ATTACHMENT 1 – Council Submission

SSD-78520463 - 54-56 Anderson, Chatswood

Figure 1: WLEP 2012 Heritage Map

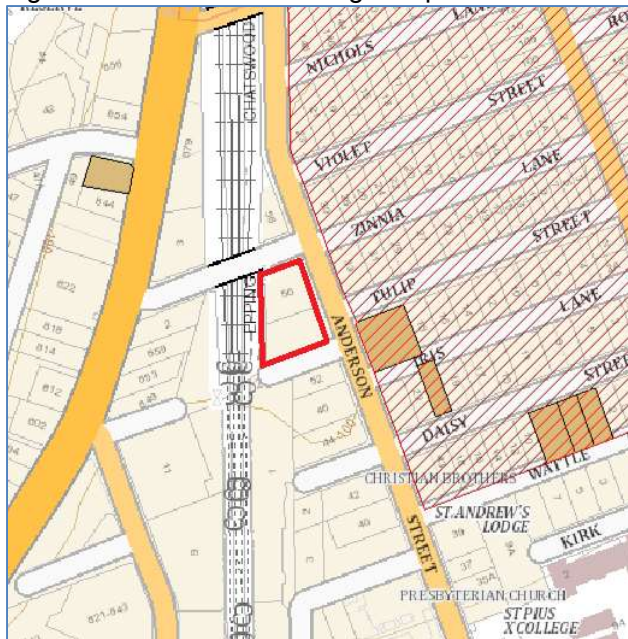
In its review of the draft CBD Strategy in 2019, DPHI raised concerns with such a height on the CBD boundary, with particular regard to low density residential conservation areas (with a maximum height of 8m). DPHI required Council to undertake a review of heights along the CBD boundary. The subject site is opposite the North Chatswood Conservation Area, which contains items of local heritage significance at 20 Tulip Street and 21 Daisy Street. Refer to Figure 1 below which shows the subject site in context with the conservation area and surrounding heritage items.

Having regard to the circumstances of this site and its location on the CBD boundary, Council is supportive of a shop top housing development consistent with WLEP 2012 controls. In Council's view, heights above 90m should not be located on the CBD boundary adjacent to low density residential conservation areas.

Figure 2: Pillars and doors opening on through site link

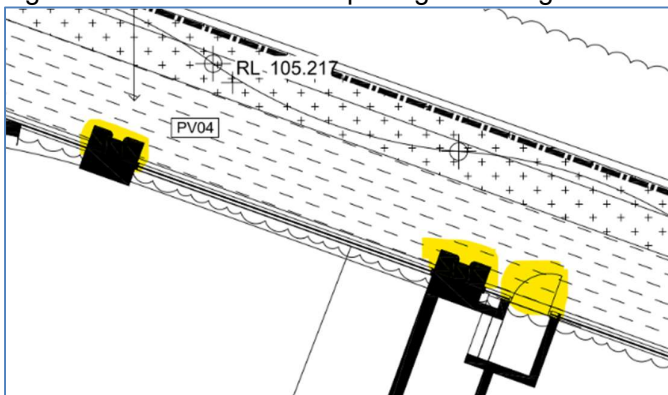
There is concern with regard to the width of the through site link pathway which is narrowed by the pillars protruding into the pathway. There is also concern regarding the doors opening onto the pathway being a safety issue for people using the pathway. See the image below:

Council requests the pillars located within the through-site link to be further set back to improve accessibility. The doors exiting to the pathway should open inwards only. This is easily achievable through a redesign and conditions of consent.
